Proposed Revisions to a Standard Plans Index

Index Number: 515-022

Sheet Number (s): 3 of 3

Index Title: Pedestrian/Bicycle Bullet Railing Details

INDEX
515-022

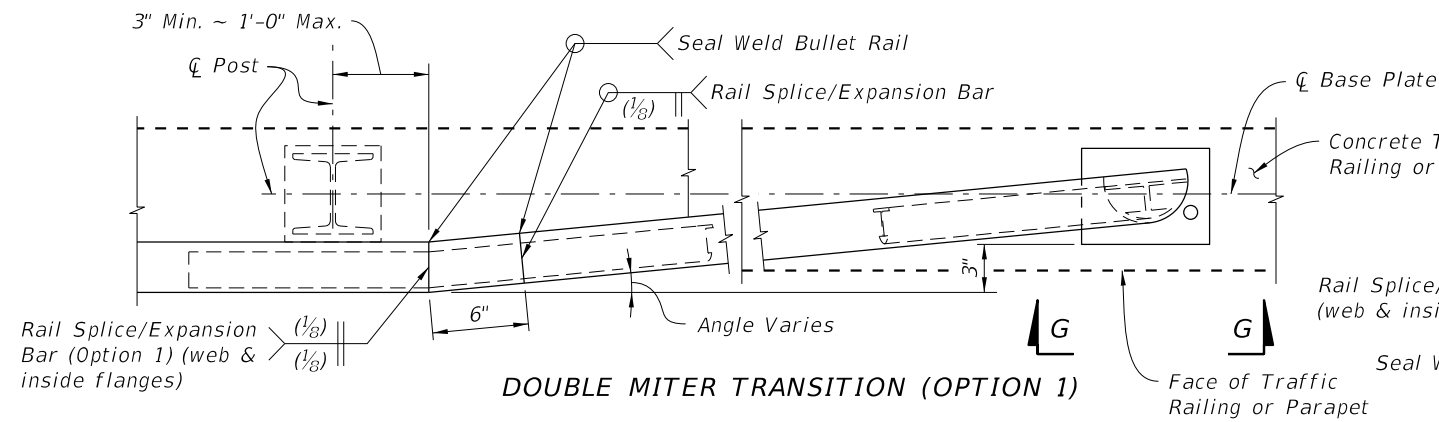
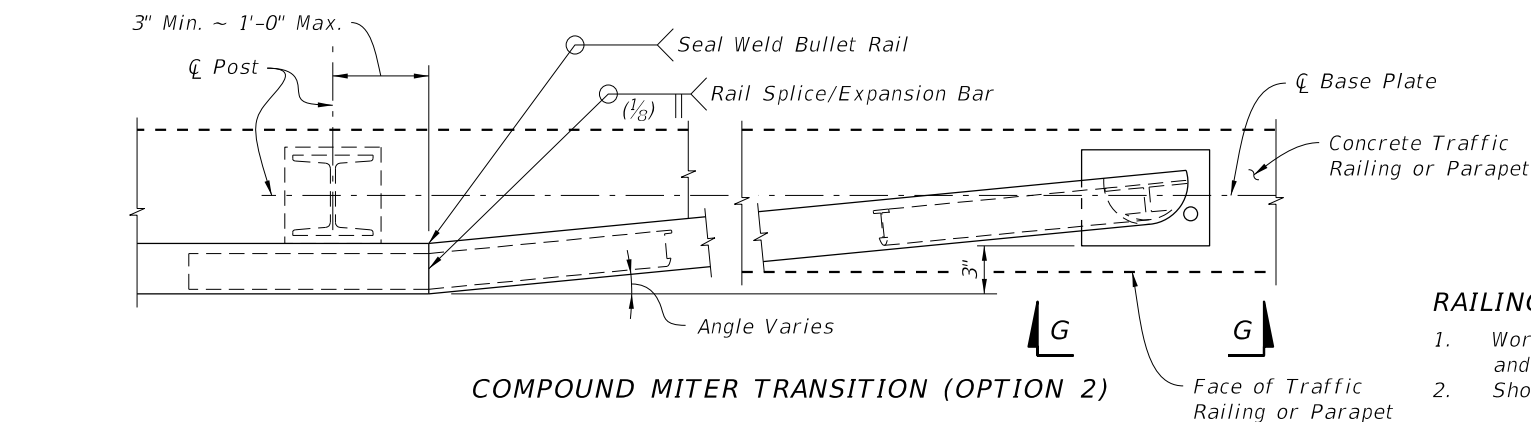
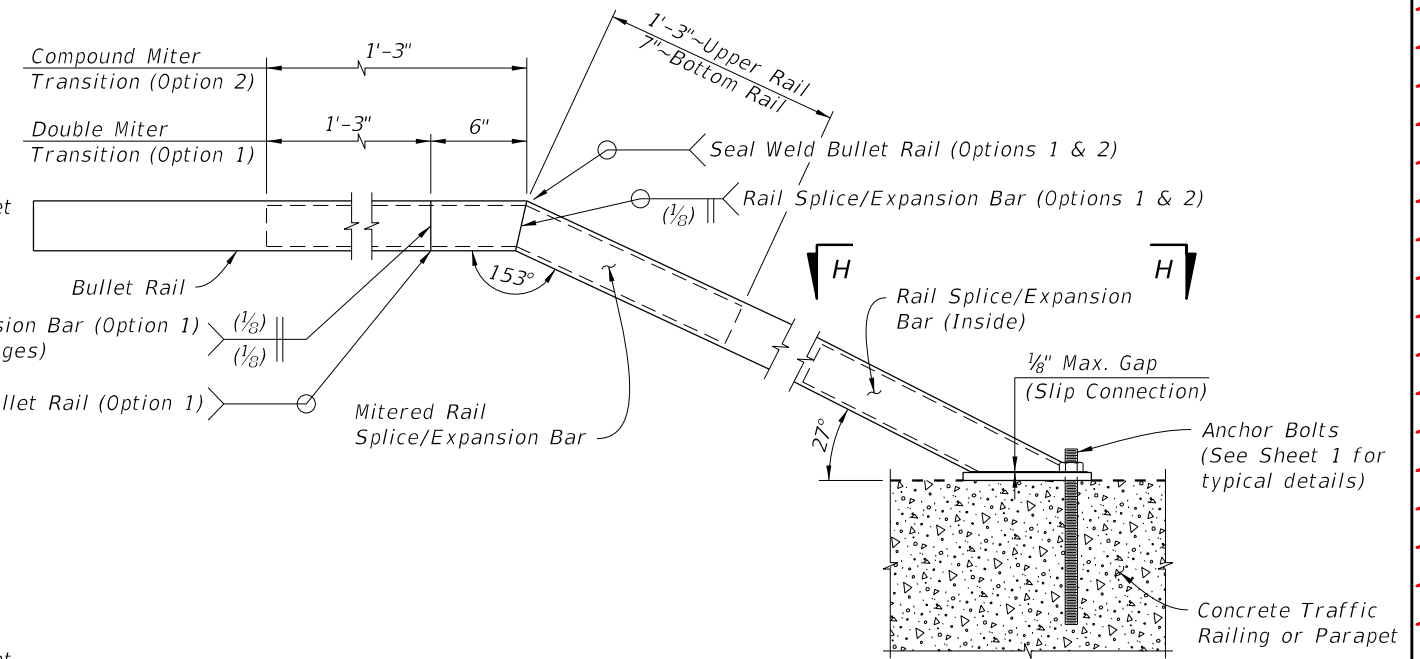
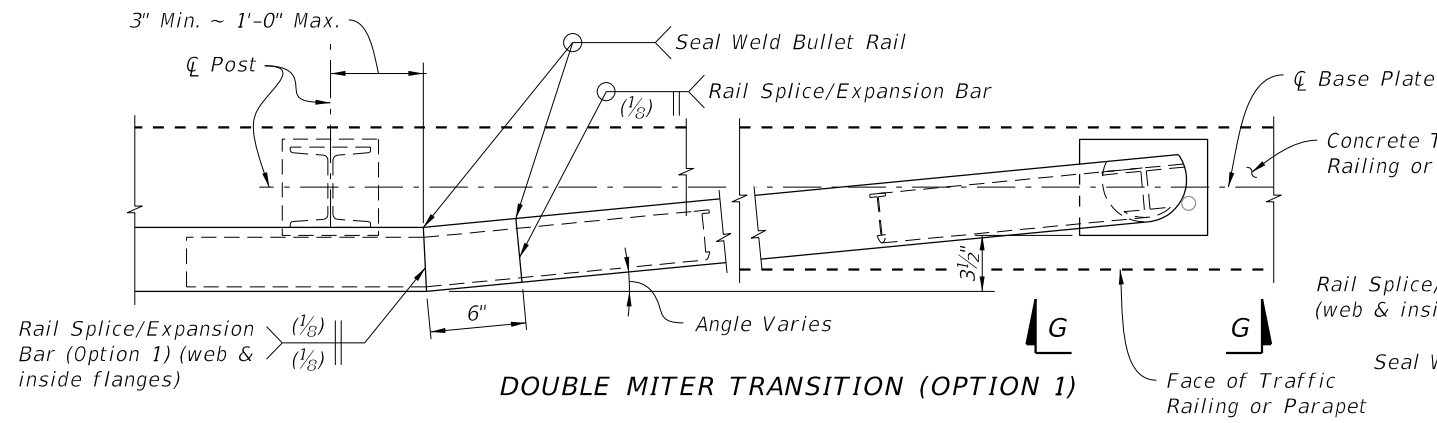
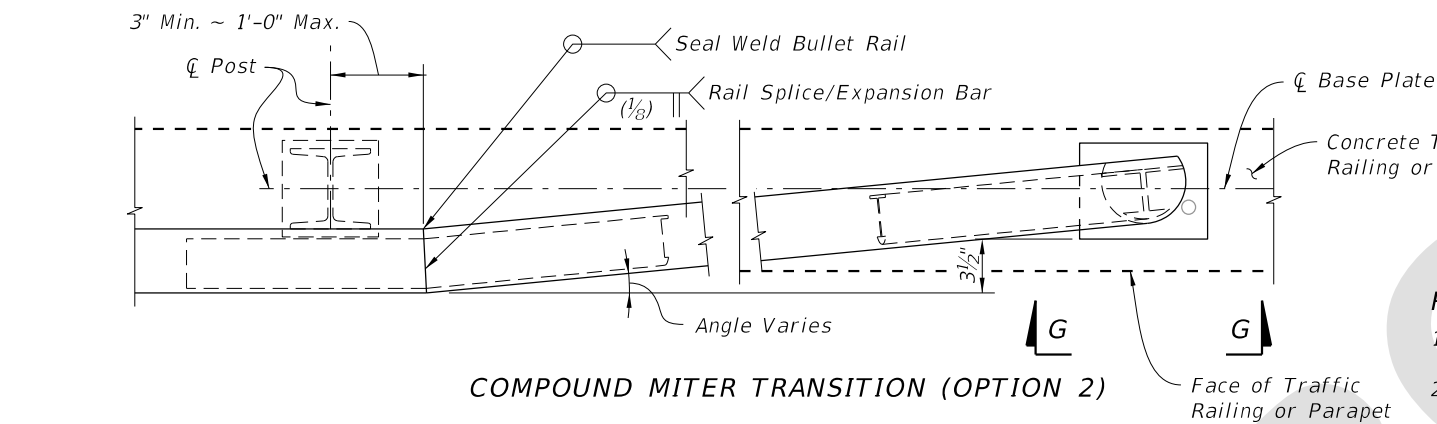
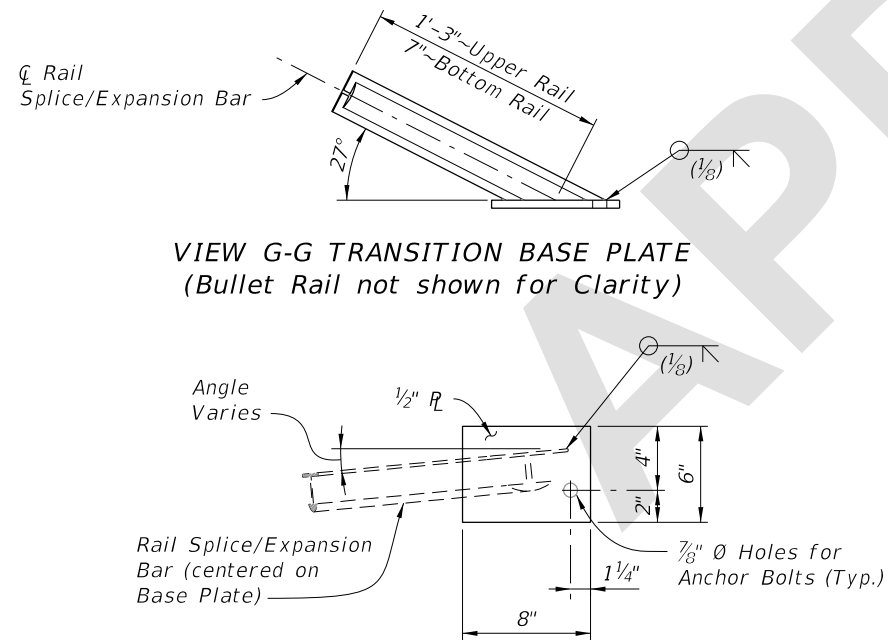
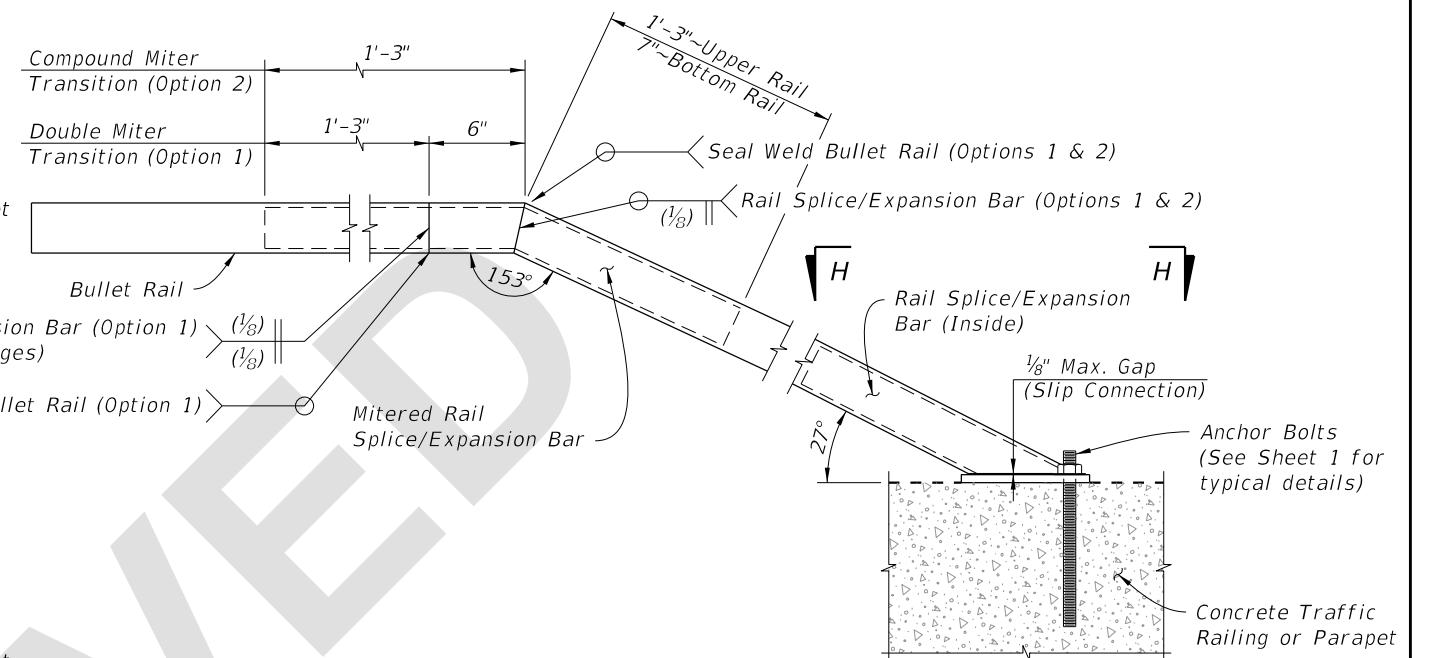
Sheet 3: Corrected the relative location and dimensions of the base plate and post with respect to the edge of the bullet rail.

Dimensions and drafting associated with the rail were corrected to reflect its correct orientation. The rail had been drafted as if it were facing down in plan which was incorrect.

VIEW G-G TRANSITION BASE PLATE
(Bullet Rail not shown for Clarity)

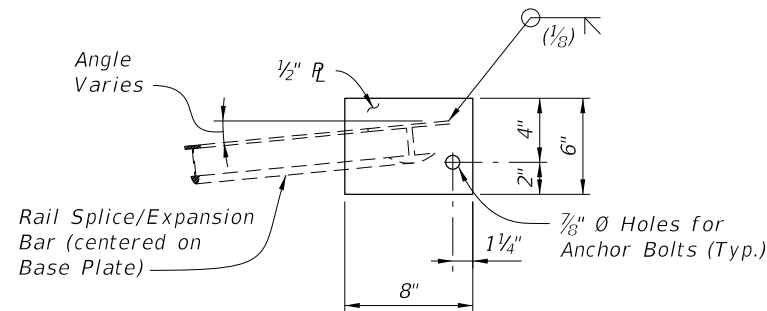
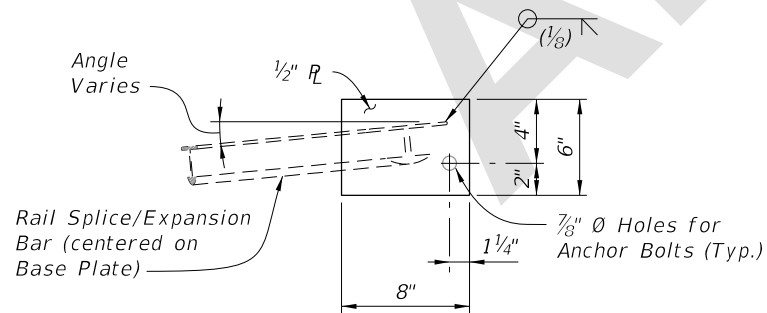
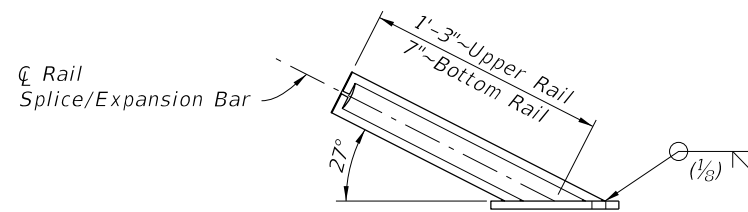
Edited details to correct the orientation of the rail.
